DOCKETED	
Docket Number:	23-OPT-01
Project Title:	Fountain Wind Project
TN #:	255883
Document Title:	fwp_wildfire_response_to_ROCs_memo
Description:	N/A
Filer:	Caitlin Barns
Organization:	Stantec Consulting Services, Inc.
Submitter Role:	Applicant Consultant
Submission Date:	4/23/2024 8:52:33 AM
Docketed Date:	4/23/2024

Reference: Fountain Wind Project Wildfire Supplemental Information and Response to CAL FIRE Records of Conversation

Notes
 1. Coordinate System: NAD 1983 2011 StatePlane California I FIPS 4011 F1 US
 2. Service Layer Credits: ESRI online services, 2019

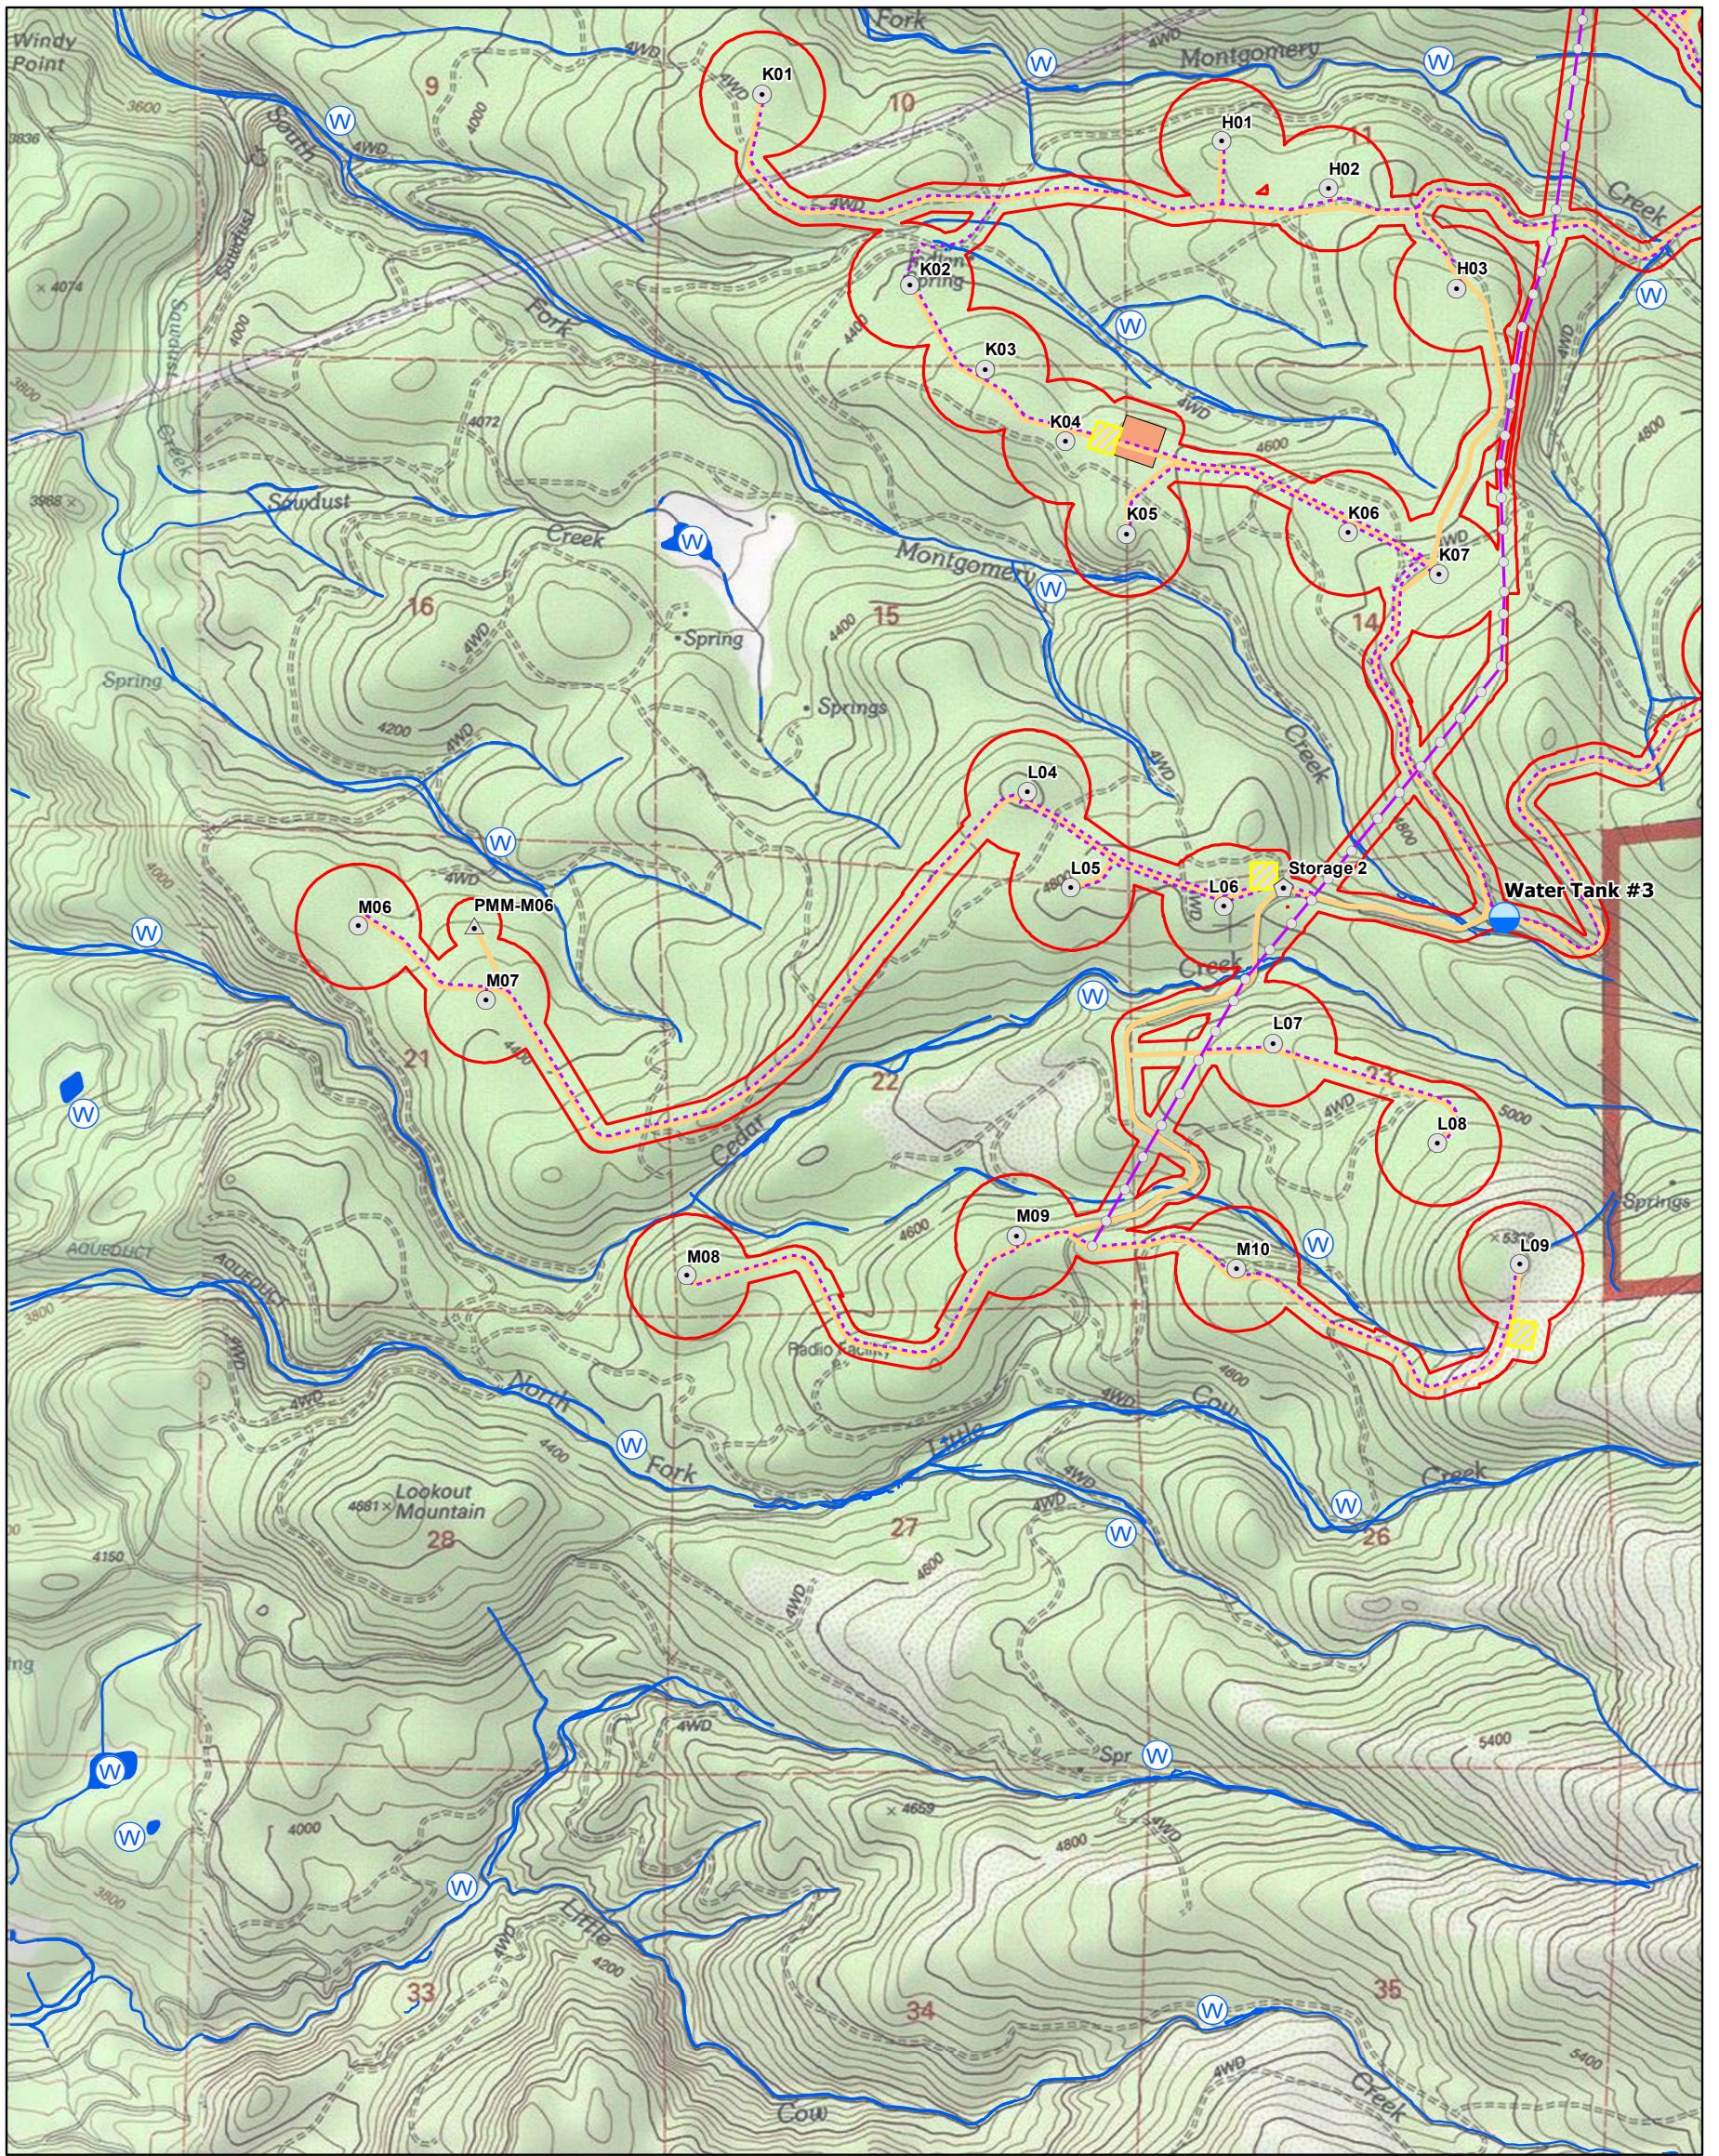
Shasta County Fire Department Answer: CAL FIRE noted that they would likely let the fire burn out and have personnel onsite to monitor it and put out any incidental fires triggered by embers. CAL FIRE noted that the planned onsite water tanks would not be very useful in firefighting as they would need to be refilled for continuous use, that there is no water supply in the area, and that a hydrant system would be more useful.

Shasta County Fire Department Answer: No. The 5000-gallon tanks would only provide a few fill ups of the average fire engine tank which holds 500-1000 gallons. If no other sources of water are available onsite it would need to be trucked in by water tender trucks with average volumes of 3500 gallons or drafted from a local water source/feature. The Chief indicated that if the tanks are gravity fed then they are not adequate for firefighting use. He would prefer to see a hydrant system installed on the project site and has discussed and requested this during a meeting with the Applicant. The required adequate fire flow for the buildings would be calculated by Shasta County Fire for final building design and permitting.

available for future firefighting use. Third, water for firefighting would be available from the new well and associated storage tank at the Operations and Maintenance facility. Finally, fire fighters commonly draw water for fire suppression from nearby surface waters. Surface water features exist on and near the Project site and could be available to refill engines and water tenders. Nearby water sources are identified on Figure 1.

The CEC is referencing the 10,000-gallon helicopter dip tank that currently exists at the project site. This tank can be used by equipment and apparatus other than helicopters to source water. Up to three new 5,000-gallon tanks, and a water storage tank that would supply the O&M building and be connected to a new well, will also be installed onsite and can be used for ground-based firefighting operations. All onsite tanks and water sources as shown in Figure 1 and 2 will be available for immediate refill during a fire incident response with water tender relay operations, as is standard practice for Shasta County Fire Department. Figure 2 shows locations of nearby perennial surface waters also available for fire response.
